CAVENDISH ER BRF 0146 (13)
CONTRACTOR FABRICATED PRE-CAST

SHEET1:ABUTMENT #1 PLAN
SHEET2:ABUTMENT #2 PLAN
SHEET3:ABUTMENT #1 ELEVATION
SHEET4:ABUTMENT #2 ELEVATION
SHEET5:APPROACH SLAB #1 PLAN
SHEET6:APPROACH SLAB #1 CASTING PLAN
SHEET7:APPROACH SLAB #2 PLAN
SHEET8:APPROACH SLAB #2 CASTING PLAN
SHEET9:POST TENSIONING DETAILS
SHEET10:FORMING PLAN
SHEET11:ENCLOSURE DETAILS
SHEET12:ENCLOSURE DETAILS
SHEET13:QUALITY CONTROL
SHEET14:GENERAL NOTES
SHEET15:REINFORCING STEEL
SHEET16:CONCRETE MIX DESIGN
SHEET17:TEMPORARY BEARING LAYOUT
SHEET18:BEARING DETAILS AND NOTES

REVISION # 1 11-19-13

COVER SHEET/INDEX

SHEET NUMBER 2

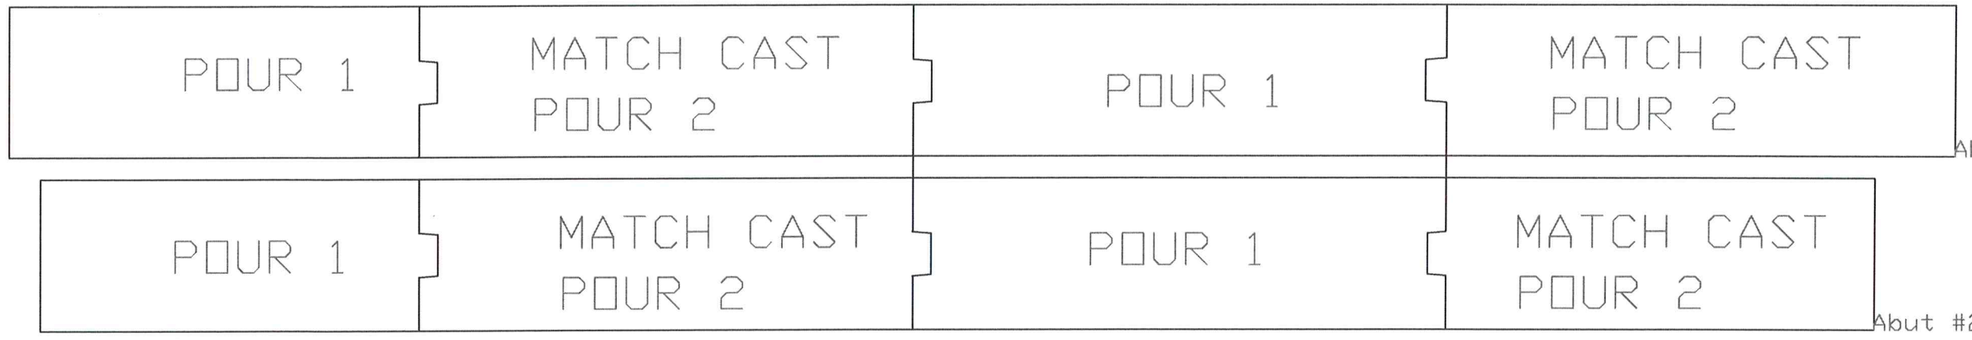
NOTE:
USE MECHANICAL CONNECTOR #6 EPOXY COATED IN WINGWALLS AND ABUTMENTS EACH FACE AND SEAT LEVEL
EPOXY COATED MECH CONNECTORS APPROVED BY PROJECT MANAGER 11-19-13-GALVANIZED NOT REQUIRED

SHEET NUMBER 3

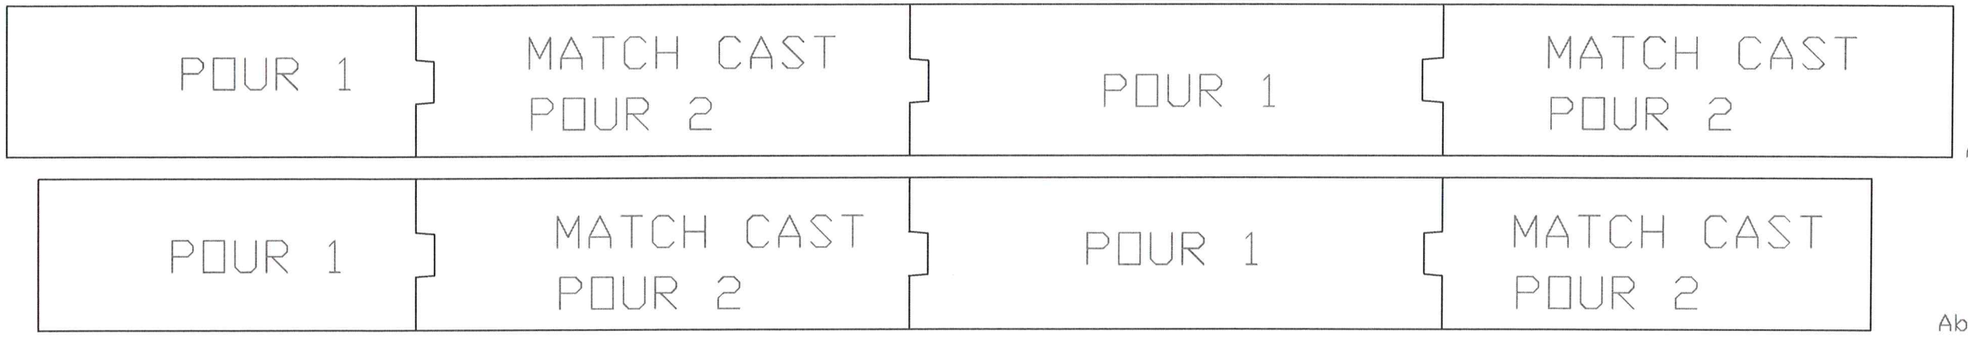
NOTE:
USE MECHANICAL CONNECTOR #6 EPOXY COATED IN WINGWALLS AND ABUTMENTS EACH FACE AND SEAT LEVEL
EPOXY COATED MECH CONNECTORS APPROVED BY PROJECT MANAGER 11-19-13-GALVANIZED NOT REQUIRED

SHEET NUMBER 15

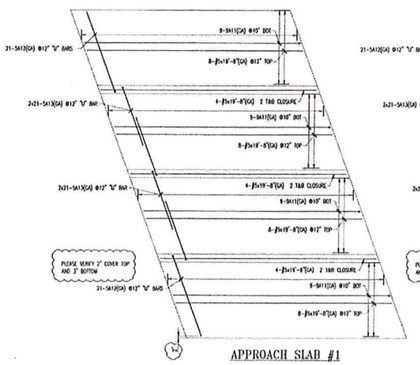
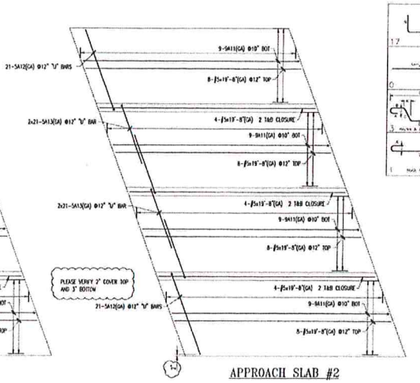
PLEASE VERIFY COVER AND LAP OF DWL BARS

ENG. AND ARCH. PLEASE VERIFY ALL CLOUDED AREAS
